Title			Face Detection Attendance Machine iF11		
Size C		Number		Revision	
Date: 1/04/2025			Sheet of		
File: D:\Alitum\iF11M.SchDoc			Drawn By: Bhu

LCD LDO

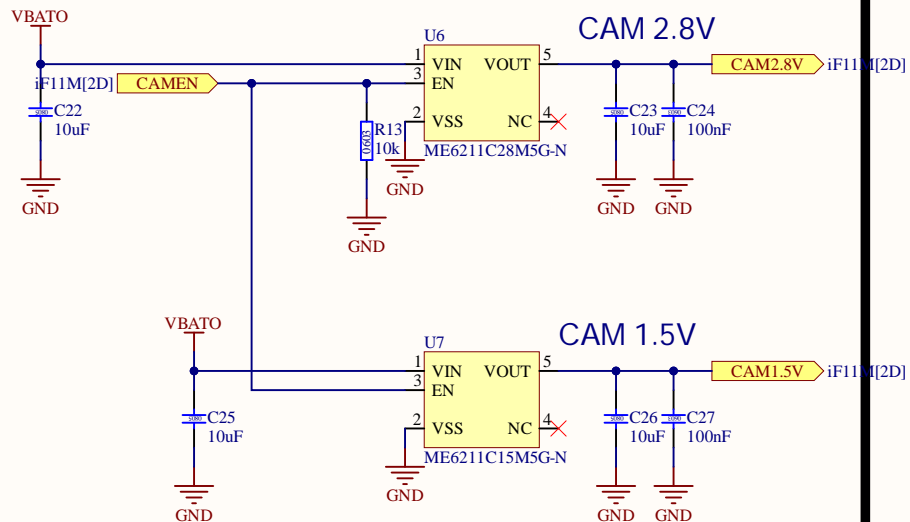
LCD LDO should be 2.8V for safer operation

Battery Charging & Protection

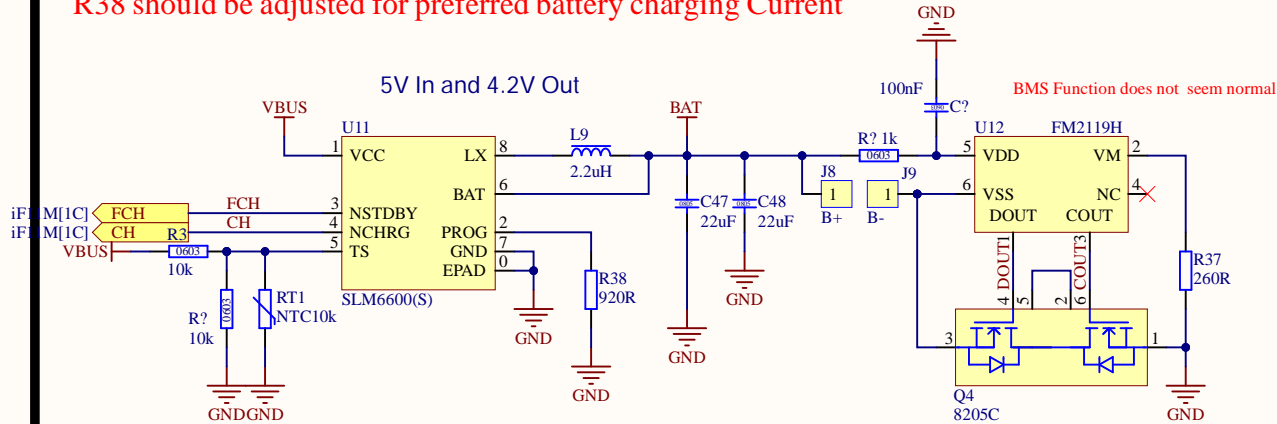
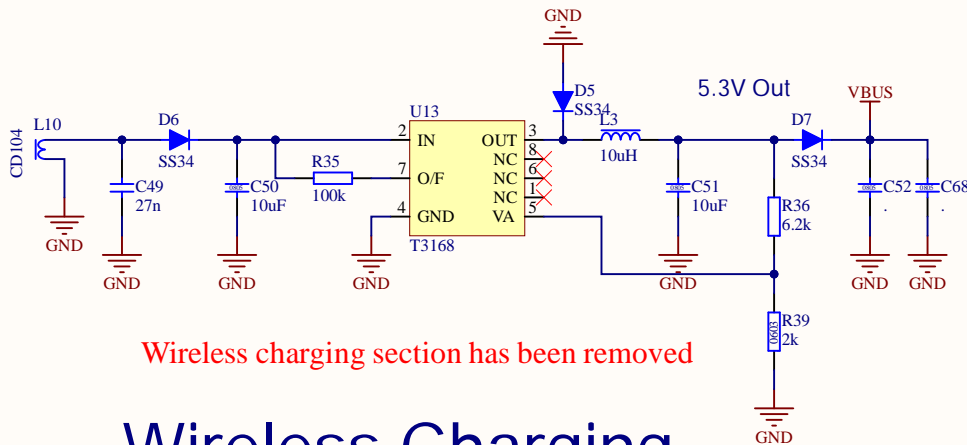
R38 should be adjusted for preferred battery charging Current

BMS cuts power at 2.4V which is unnecessary. BMS should be changed or removed
